GROUP	MODEL
	BOD	**2026MY Sorento Hybrid and Plug-In Hybrid (MQ4 P/HEV)**
	NUMBER	DATE
	359	**September 2026**

TECHNICAL SERVICE BULLETIN

SERVICE ACTION: FRONT VIEW CAMERA REPLACEMENT (SA656)

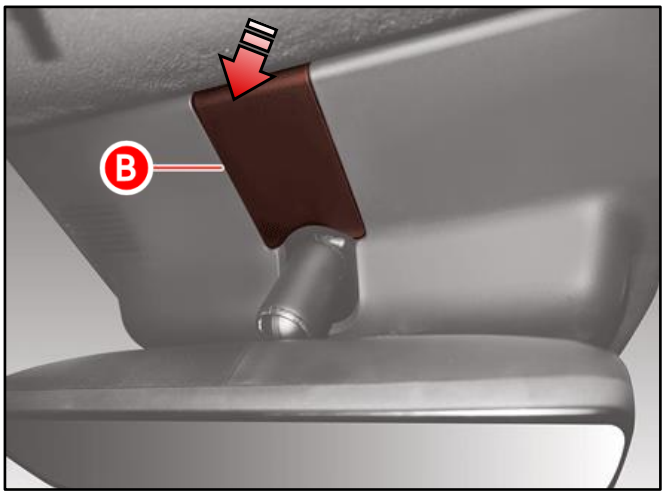
Remove the blanking cover (B) by hand. Using a pry tool/screwdriver can damage the headliner and/or blanking cover.

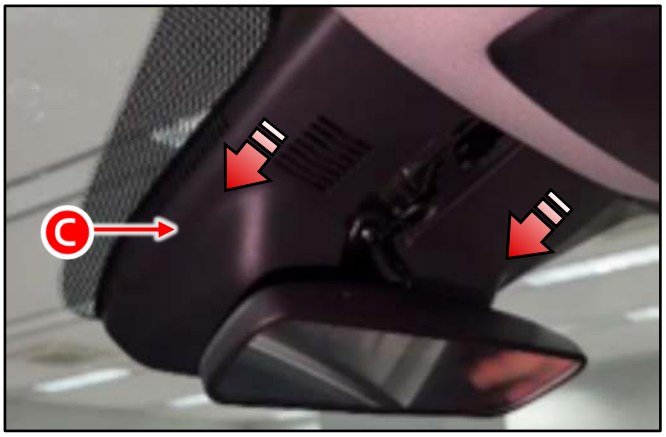
To avoid breaking the clips/tabs, slide the sensor cover (C) down while pressing it against the windshield.

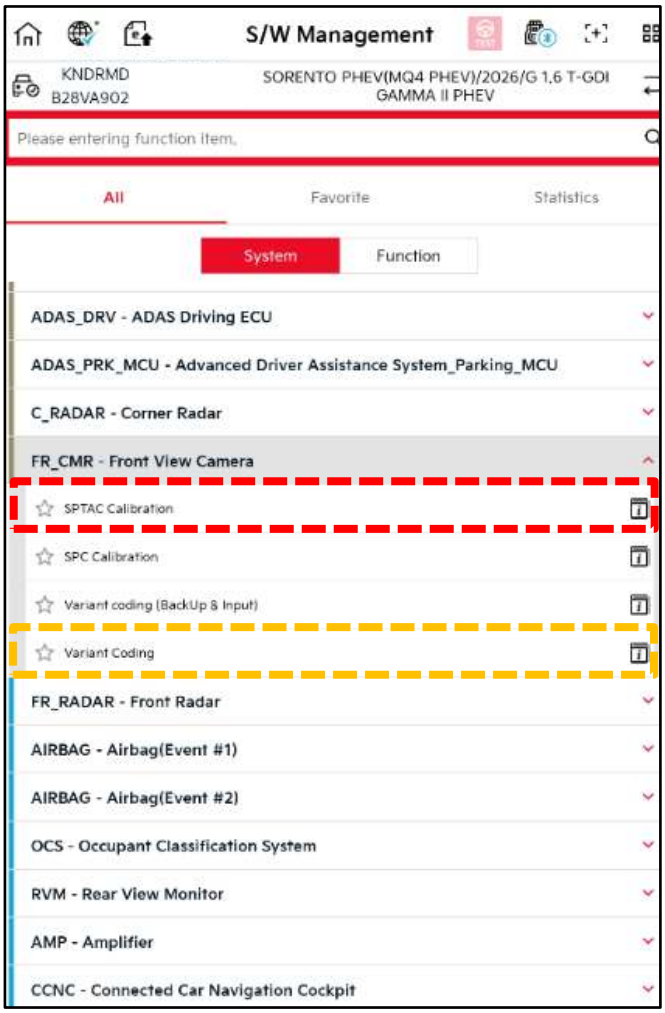
To help prevent breaking the clips/tabs when reinstalling the sensor cover (C), press the sensor cover against the windshield and slide up.

Ensure the front camera mounting area (windshield) is clean BEFORE installing the front camera (A).
